Title - Sujet Roof Replacement	
Solicitation No. - N° de l'invitation F1700-150961/A	Amendment No. - N° modif. 002
Client Reference No. - N° de référence du client	Date 2016-01-22
GETS Reference No. - N° de référence de SEAG PW-\$PWY-005-7711	
File No. - N° de dossier PWY-5-38349 (005)	CCC No./N° CCC - FMS No./N° VME
Solicitation Closes - L'invitation prend fin at - à 02:00 PM on - le 2016-01-29	Time Zone Fuseau horaire Pacific Standard Time PST
F.O.B. - F.A.B. Plant-Usine: <input type="checkbox"/> Destination: <input checked="" type="checkbox"/> Other-Autre: <input type="checkbox"/>	
Address Enquiries to: - Adresser toutes questions à: Pillay, Sal (PWY)	Buyer Id - Id de l'acheteur pwy005
Telephone No. - N° de téléphone (604) 775-9386 ()	FAX No. - N° de FAX (604) 775-6633
Destination - of Goods, Services, and Construction: Destination - des biens, services et construction: DFO - West Vancouver Lab - West Vancouver, BC

Addendum 2

Project No	5437	Date	January 21, 2016
Project	Centre for Aquaculture and Environmental Research ROOF REPLACEMENT 4160 Marine Drive West Vancouver, BC Department of Fisheries and Oceans - West Vancouver Laboratory

Structural Addendum S-2

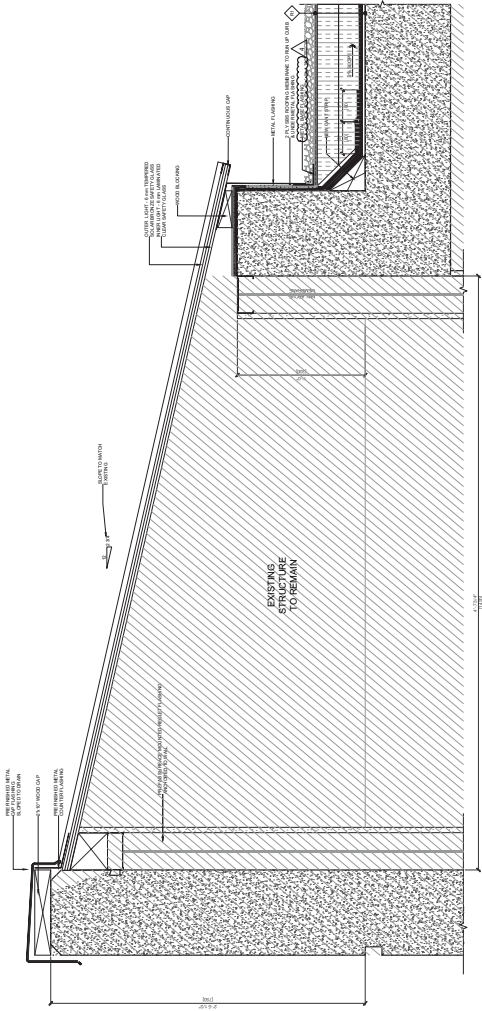
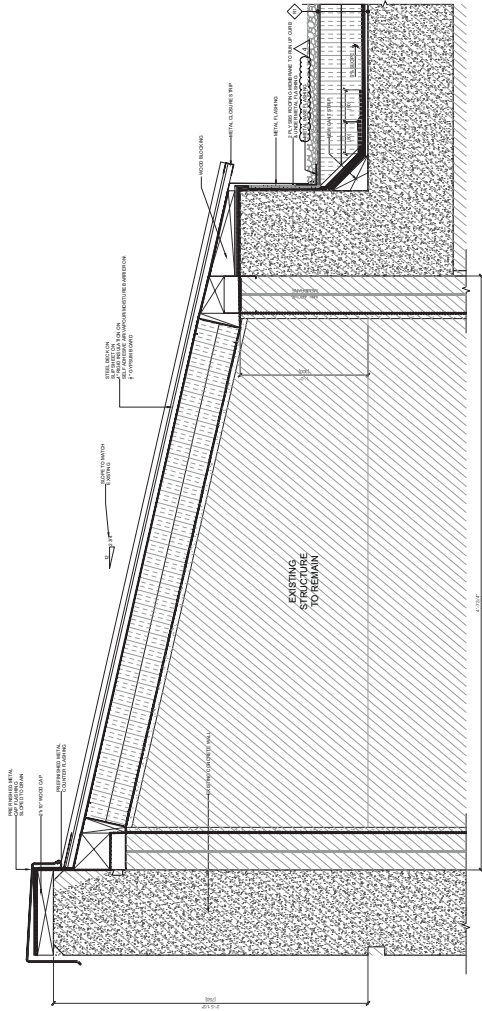
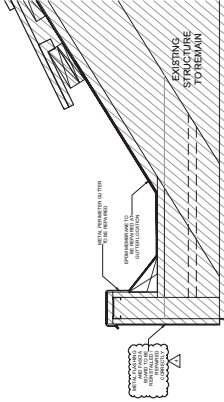
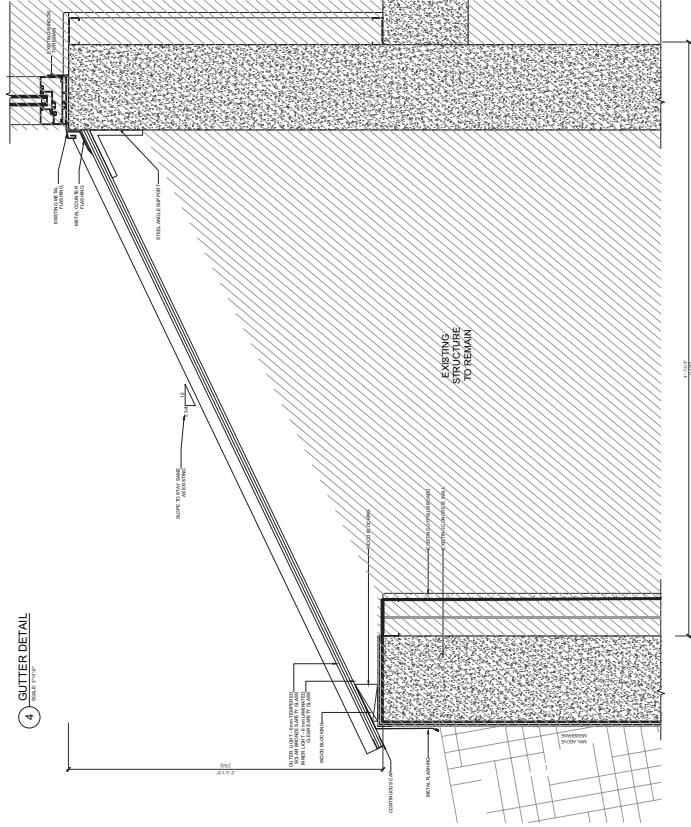
1 SKYLIGHT DETAIL
 SCALE: 1/4" = 1'-0"

2 SKYLIGHT DETAIL
 SCALE: 1/4" = 1'-0"

3 SKYLIGHT DETAIL
 SCALE: 1/4" = 1'-0"

4 GUTTER DETAIL
 SCALE: 1/4" = 1'-0"
